# MEMORANDUM

**FILE NO.:** CSP2014 0006

**PROPOSAL:** Review of Alaska DOT&PF project 68471, Glacier Highway reconstruction and pedestrian improvements from Fritz Cove Rd to Seaview Ave, for consistency with locally adopted plans and ordinances.

**Figure 1: Cross section of Glacier highway as proposed by DOT&PF, with and without a center turn lane.**

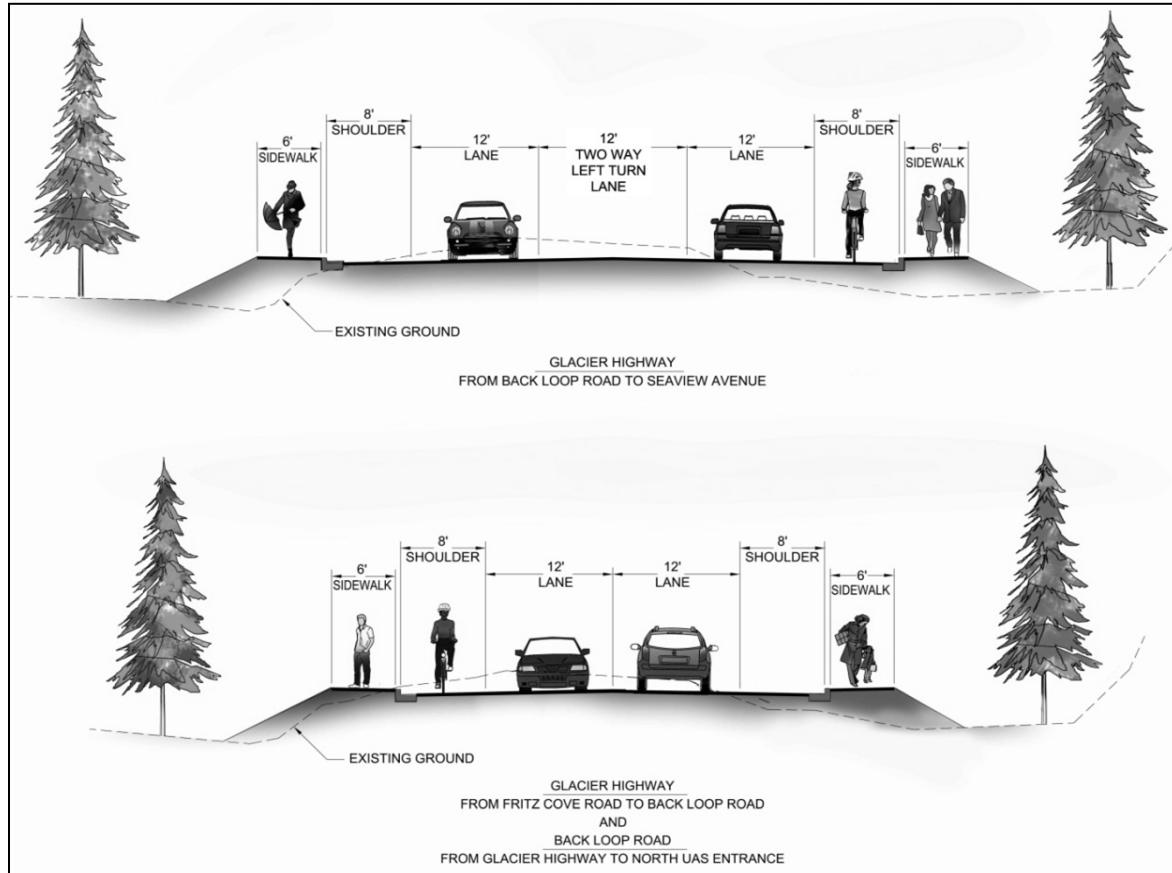
The proposed project will widen Glacier Highway to include two twelve foot travel lanes, eight foot wide shoulders, and six foot wide sidewalks on both sides of the road along the full length of the corridor. In addition, a 12 foot center turn lane would be included at the curve west of Fritz Cove Road to access the Anderson Building and former Auke Bay Lab area, as well as through the commercial district of Auke Bay from the intersection of Mendenhall Loop Road to just east of Bayview Avenue. (See Figure 1 and Attachment A)

There are several design features that are not shown in these basic cross sections. As part of this project, the speed signs from Fritz Cove Road to Mendenhall Loop Road (Back Loop Road) would be corrected to reflect the current Speed Limit of 40 mph. To safely allow for drivers to travel at the current speed limit of 40 mph, the curve west of Fritz Cove Road would be straightened and elevated to allow for safe speeds up to 40 mph. This curve realignment would require the fee simple acquisition of part or all of nine pieces of property (See Attachment C).

**Figure 2: Crosswalk and raised median proposed in front of Auke Bay Elementary School.**

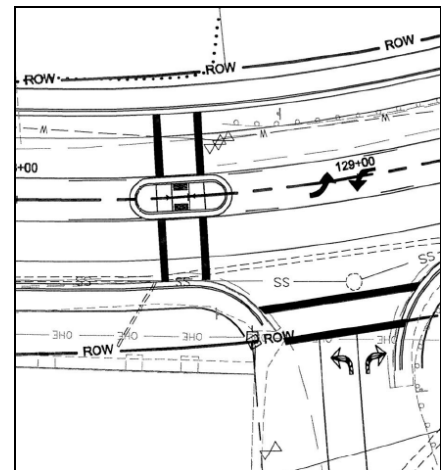
Implementing Action 19 has also been adequately addressed. The crosswalk in front of Auke Bay Elementary School includes a median pedestrian refuge, as the plan calls for. Although this project does not include medians to control left turns onto Glacier Highway, the provision of a center turn lane has been limited to areas where it is needed by those turning left off of Glacier Highway.

**Figure 6: The indirect turn proposed by DOT&PF to improve left hand turns from Auke Lake Way onto Glacier Highway.**

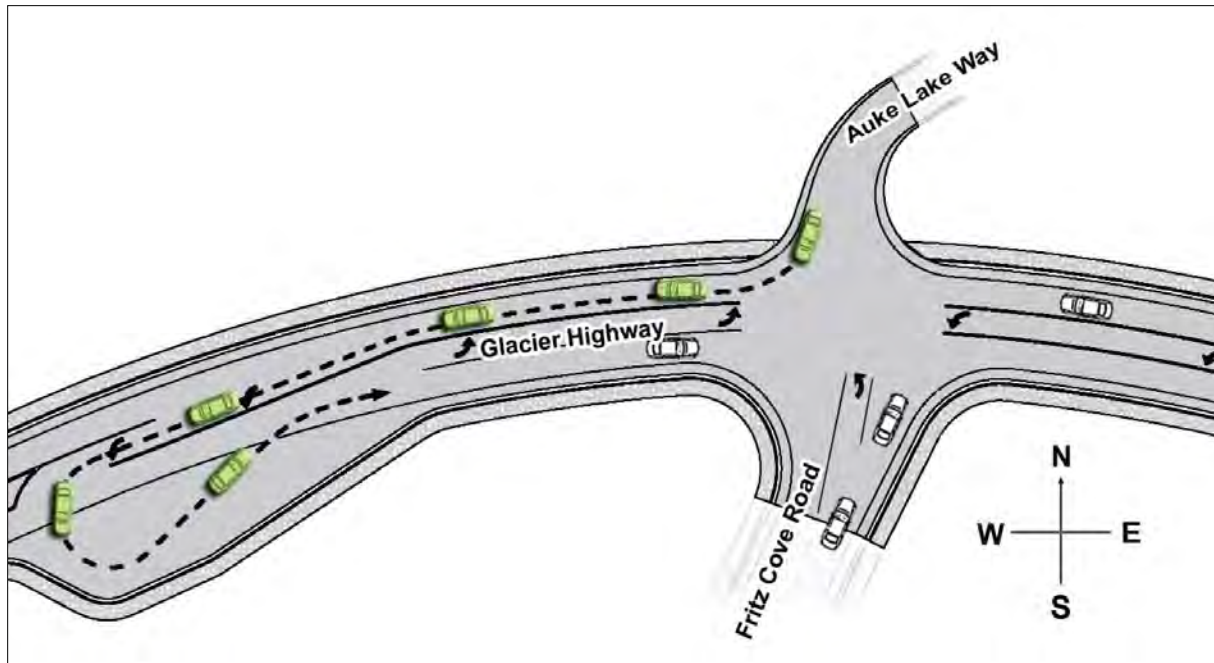
Improvement #4 of the NMTP recommends a roundabout or traffic light at the intersection of Fritz Cove Road/Auke Lake Way and Glacier Highway. In public comments during this project review and in past planning processes for the project area, many community members have suggested that turning left out of Fritz Cove Road onto Glacier Highway is challenging. Many perceive the movement to be unsafe. Furthermore, some are worried that increasing the design speed at the curve past the Anderson Building to the west will make this movement even more difficult.

DOT&PF staff has responded to this concern by stating that when the sidewalk is installed up to Fritz Cove Road, the guard rail will be pulled back, improving visibility. Straightening the curve and super-elevating it will also improve visibility for drivers at the intersection of Fritz Cove Road and Glacier Highway.

- 4) While some provisions have been made for traffic calming through the commercial section of the corridor, no traffic calming is provided from Harbor Road to Fritz Cove Road, and the straightening of the Anderson Building curve will lead to an increase in operational speeds along this stretch of roadway. Staff recommends that some traffic calming element be added near this end of the project area, consistent with the requirement for traffic calming in the Area Wide Transportation Plan and the design recommendations of the Non-Motorized Transportation Plan. This could be a raised median near the indirect left turn lane, a narrowing of the painted travel lanes to 11 feet from Fritz Cove Road to Harbor Road, or some other traffic calming measure deemed appropriate by DOT&PF staff. Staff recommends Condition #6 in order for the project to be compliant with the Area Wide Transportation Plan, and to address public concerns about the safety of turning left out of Fritz Cove Road.

- 6) In compliance with Priority 61 of the Area Wide Transportation Plan, the applicant shall include traffic calming treatments throughout the corridor, including between Fritz Cove Road and Harbor Road. (Mandatory)
